**ADDENDUM NO. 1  
TO THE**

**GARDENDALE AND VILLAGE PARK WEST PRESSURE REDUCING STATION (PRS) REPLACEMENT PROJECT**

June 10, 2024

## **ADDENDUM NO. 1 DRAWING REVISIONS**

GARDENDALE AND VILLAGE PARK WEST PRS REPLACEMENTS		PRIS PIPING PROFILES	
SHEET 6 OF 22		DRAWING C-3	
BALBOA ENGINEERING, INC.		OLIVENHAIN Municipal Water District 1966 Olivenhain Road Encinitas, CA 92024 (760)753-6466	
DESIGN	DRAWN	CHECK	MARK
			DATE
			BY
			REVISIONS
			8/7/24 MID ADDENDUM 1

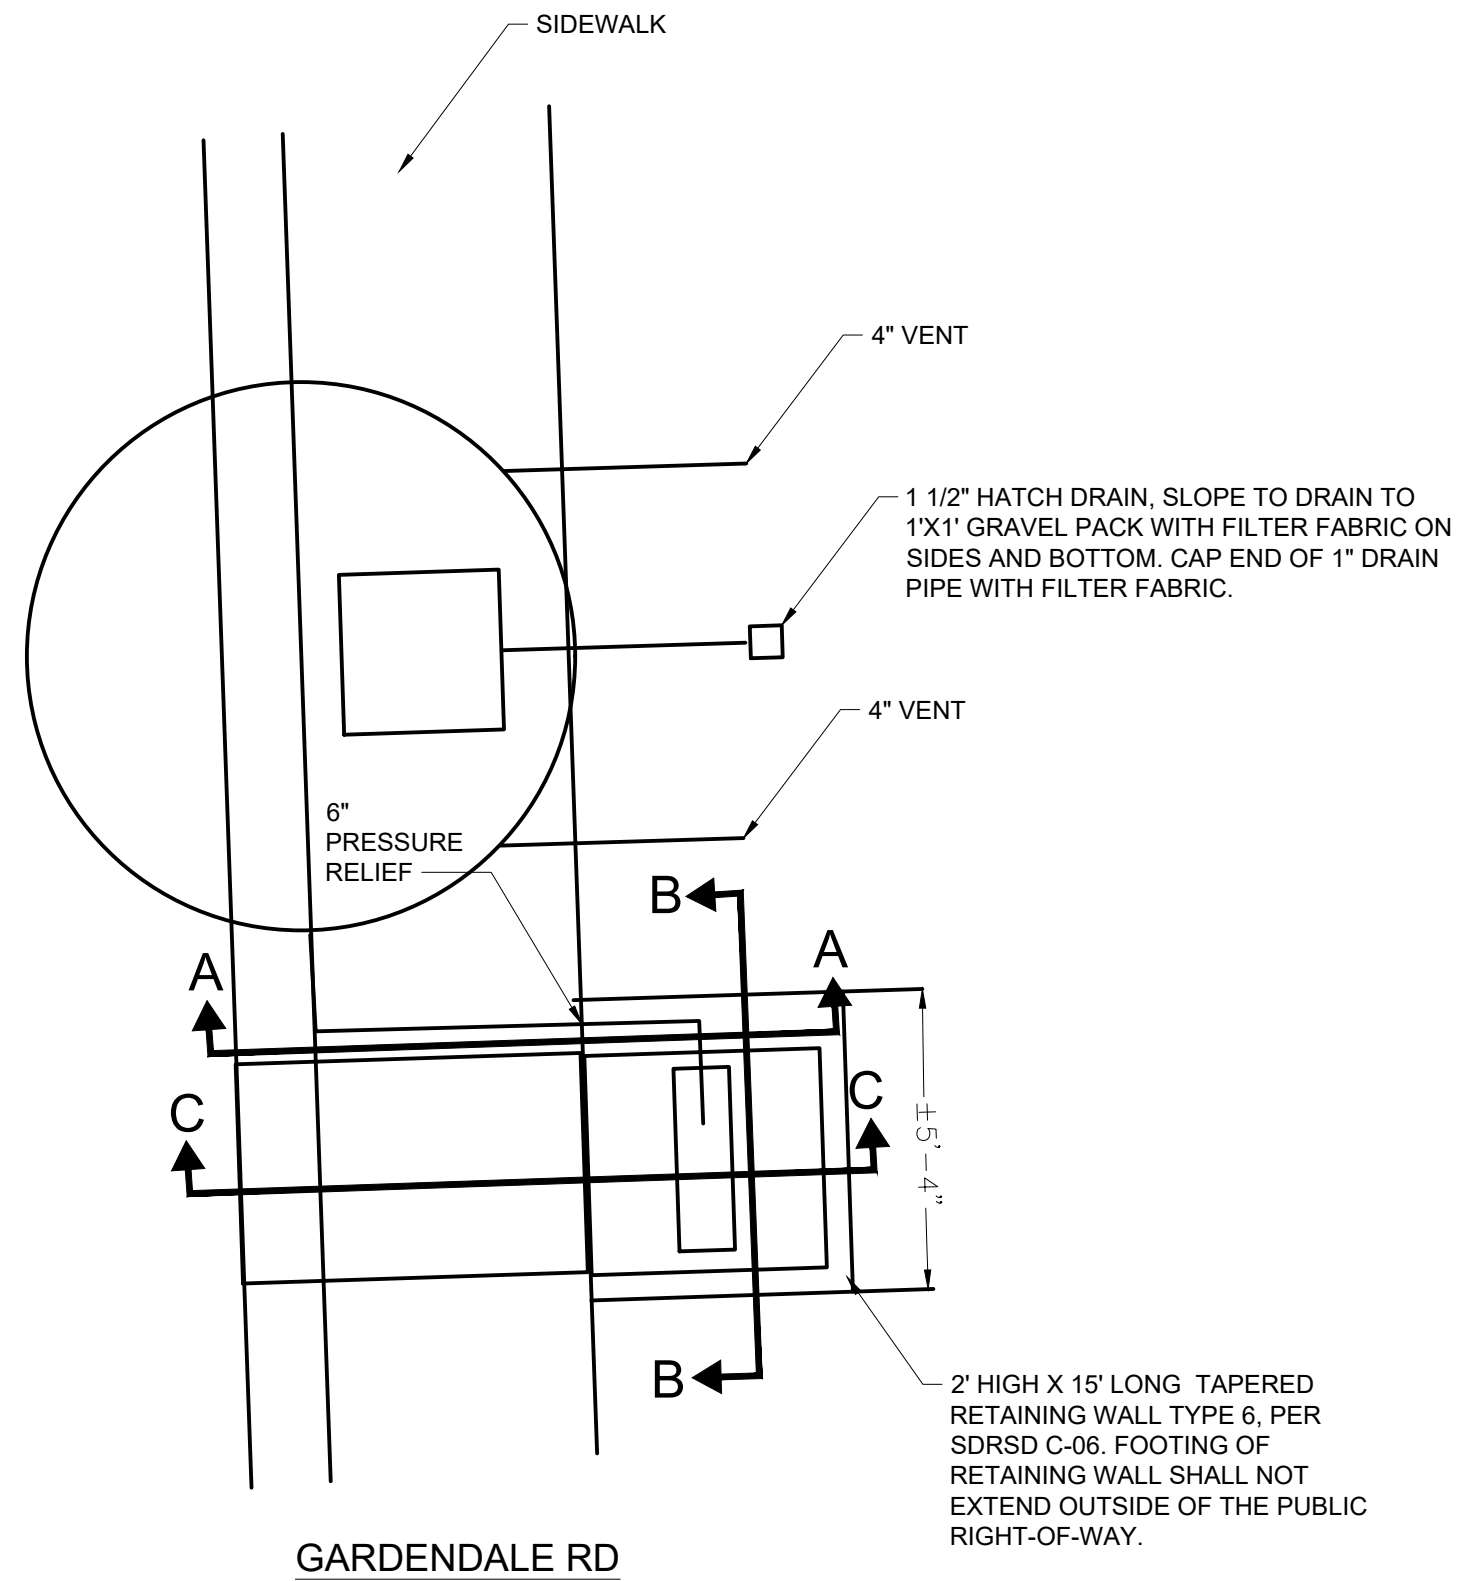
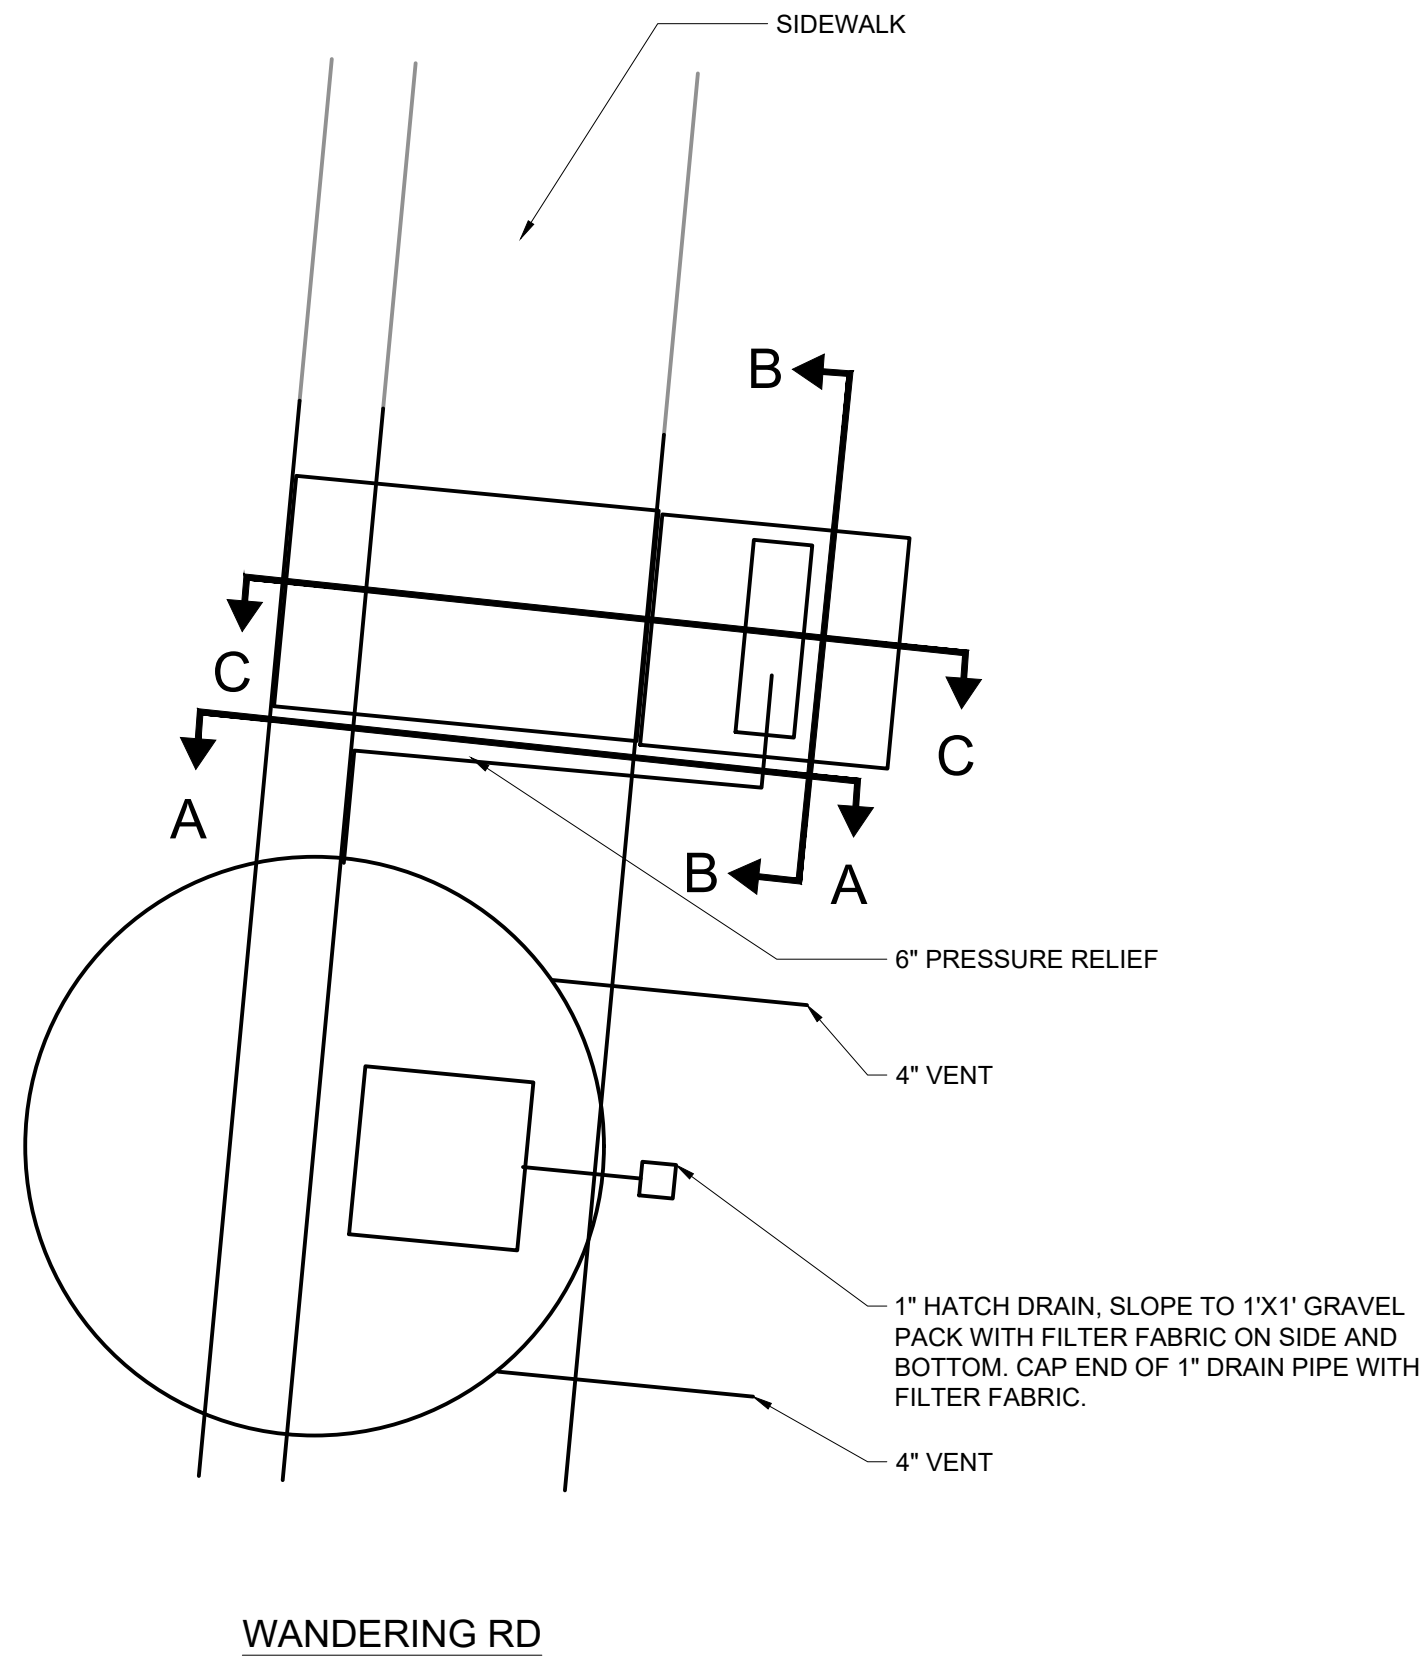
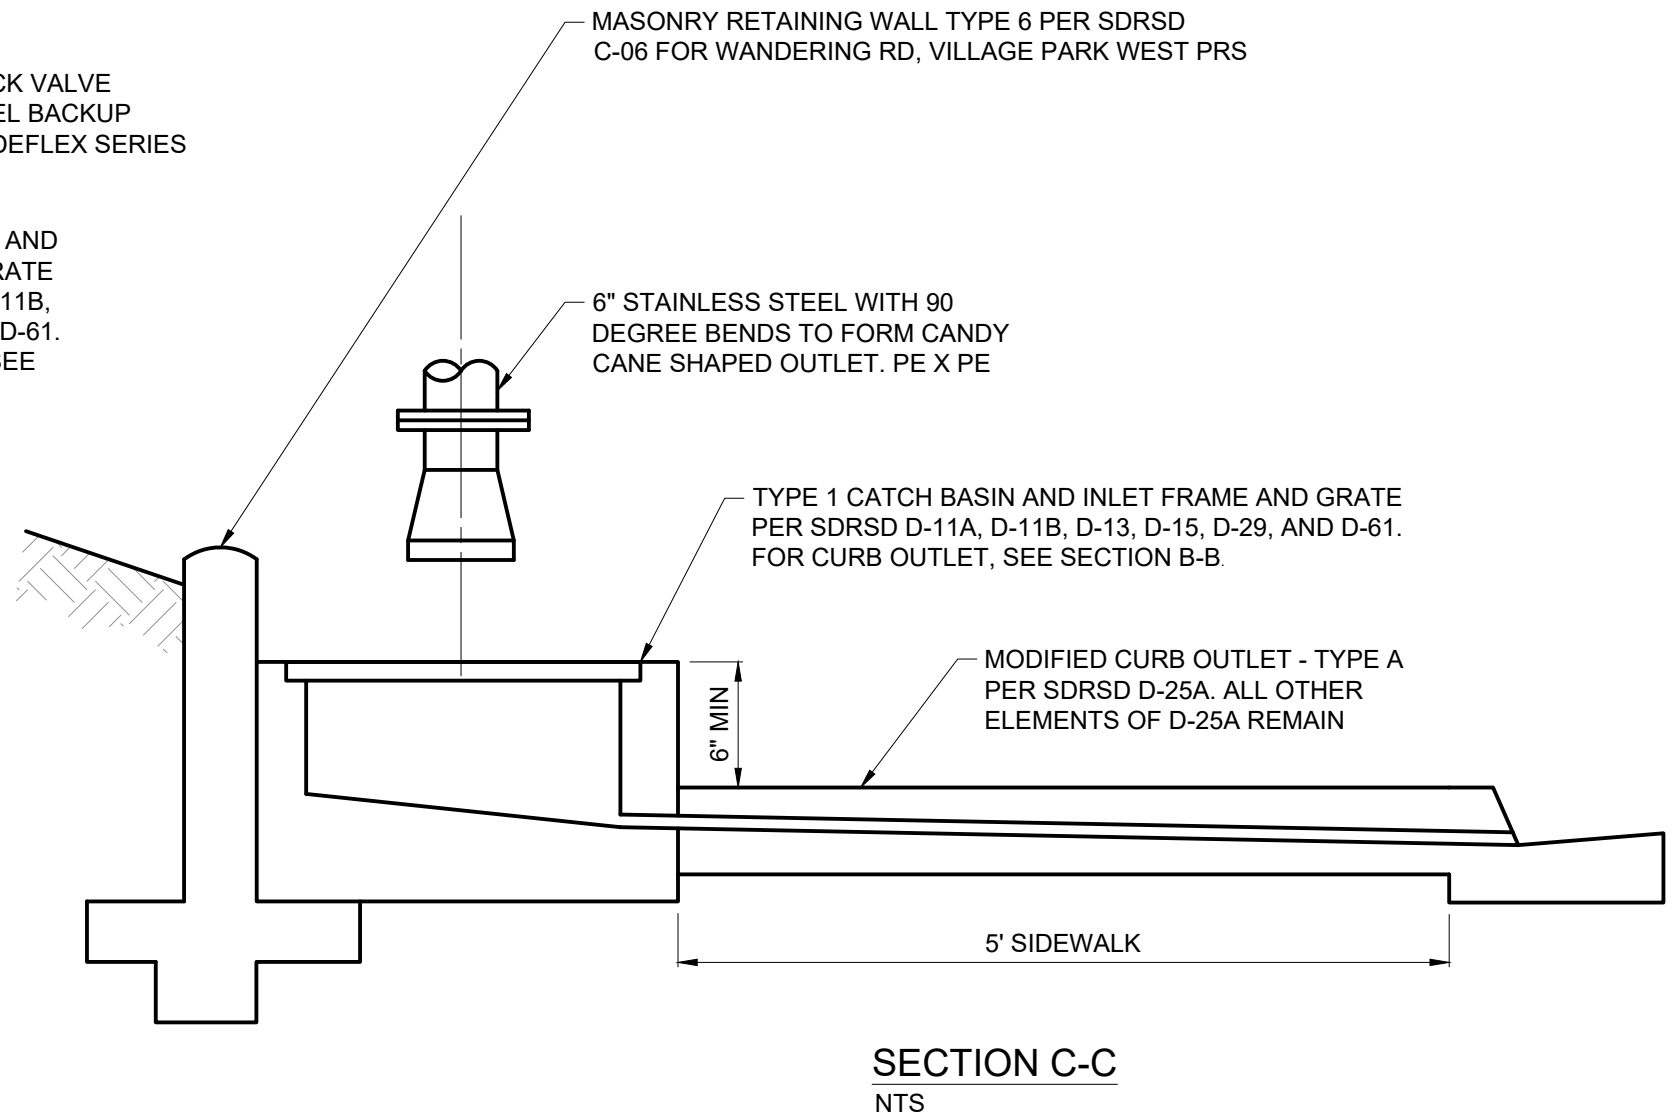
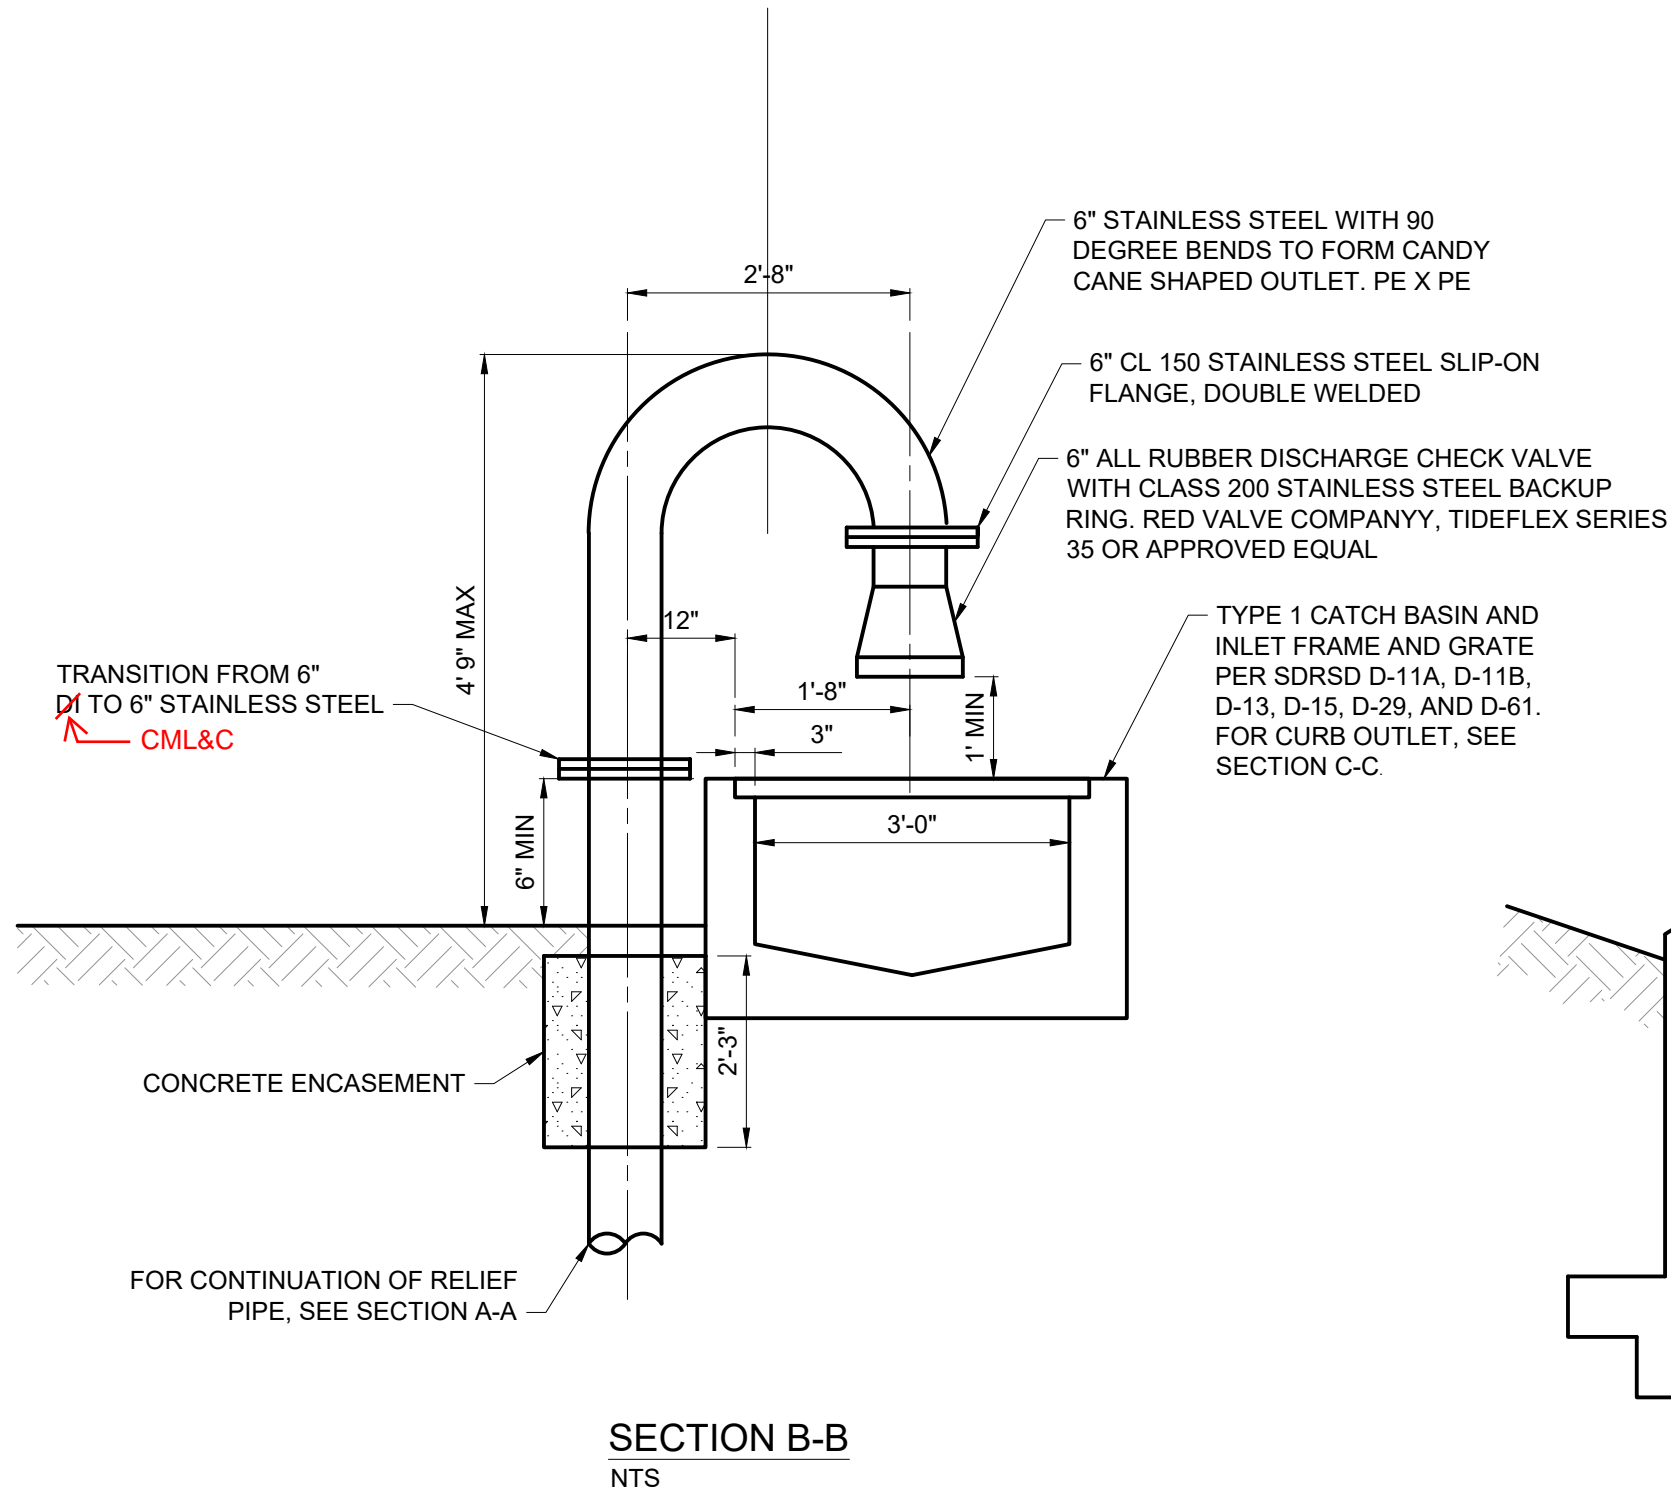
1. Drawing G-2 General Notes; **REVISE** per attached Drawing
2. Drawing C-1 Village Park West PRS, Wandering Road 10" Waterline Improvements; **REVISE** per attached Drawing
3. Drawing C-2 Gardendale Road 14" Waterline Improvements; **REVISE** per attached Drawing
4. Drawing C-3 PRS Piping Profiles I; **REVISE** per attached Drawing
5. Drawing C-4 Curb Outlet Sections; **REVISE** per attached Drawing
6. Drawing C-5 PRS Piping Detail I; **REVISE** per attached Drawing
7. Drawing C-6 PRS Piping Detail II; **REVISE** per attached Drawing
